LS-25

Refer to: HNG-14

Roadside and Geometric Design Acceptance Letter LS-25

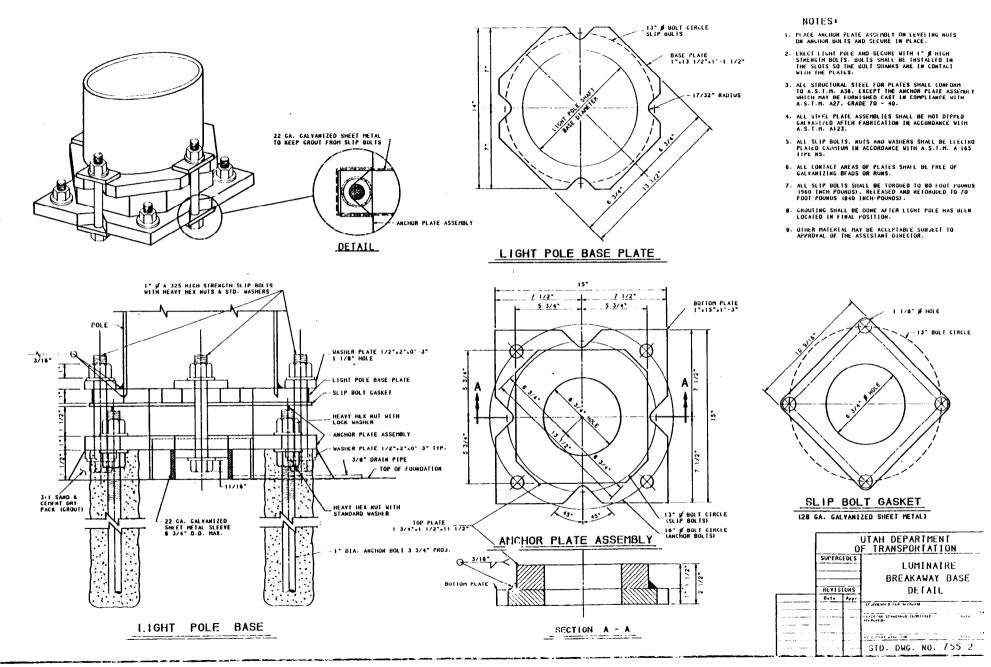
Details of the tested hardware are shown in the enclosed drawing of the slip-base. Test results and significant design details are summarized below:

<u>Test Number</u>	<u>USBLM-1</u>	<u>USBLM-2</u>
Impact Speed Vehicle Velocity Change Occupant Velocity Change	24.15 km/h (15.0 mph) 1.86 m/s (6.1 fps) 2.32 m/s (7.6 fps)	92.60 km/h (57.5 mph) 4.11 m/s (13.5 fps) 4.33 m/s (14.2 fps)
<u>Data Common to Both Tests</u>		
Vehicle Mass (Weight)	795 kg (1,750 po	unds)
Test Article Configuration Dual Mast Arm (Single or dual mast arm configuration will be acceptable.)		
Stub Height	100mm (4.0 inche	s)
Weight of Test Article 410 kg (902 pounds) (Pole mast arm and luminaire weights of up to 450 kg (1,000 pounds) each will be acceptable.)		
Luminaire Mounting Height 15.85m (52.0 feet) (Up to 17.25 m (56.5 feet) will be acceptable.)		
Bolt Circle Diameter 330mm (13 inches) (This is the minimum acceptable bolt circle.)

, Clamping Bolt Force four 1-inch bolts @ 19,126 N (4,300 pounds) each. (The four slip-bolts were torqued to 108 Newton-meters (80 foot-pounds) each, and then released and retorqued to 95 Newton-meters (70 foot-pounds.)) Pole Wall Thickness 11 gage (Minimum wall thickness for a 250mm (10-inch) diameter pole to be considered breakaway is 11 gage. This is consistent with FHWA guidelines for 3-bolt slip-bases.) 28 gage steel Keeper Plate Thickness (This is the maximum acceptable thickness.) The above information shows that the tested pole-base combination meets the change in velocity and stub-height requirements adopted by the FHWA. Therefore, the subject four-bolt slip-base for luminaire supports, as shown in the enclosed drawing, is acceptable for use on Federal-aid projects when requested by a State. Our acceptance is limited to bases where the corrosion protection of the fastener hardware is the same as the tested hardware. It is our understanding that all hardware was hot-dip galvanized except for the clamping bolts and their nuts which were cadmium plated. Galvanized clamping bolts will be acceptable if procedures are followed during their installation to assure that the same clamping force is developed in the bolts. Care must be taken during installation of the anchor bolts that the tops of the bolts do not extend above the slip-plane. The slip-base itself may not extend more than 100mm (4 inches) above a 60-inch chord, as specified by AASHTO. This acceptance is limited to breakaway characteristics of the bases and does not cover the structural features of the bases nor the poles. Presumably, you

will supply potential users with sufficient information on structural design and installation requirements to ensure proper performance. You should request certification from the manufacturer that the poles and slip-bases furnished have essentially the same chemistry, mechanical properties, and geometry as those used in the tests, and that they will meet the FHWA change in velocity requirements.
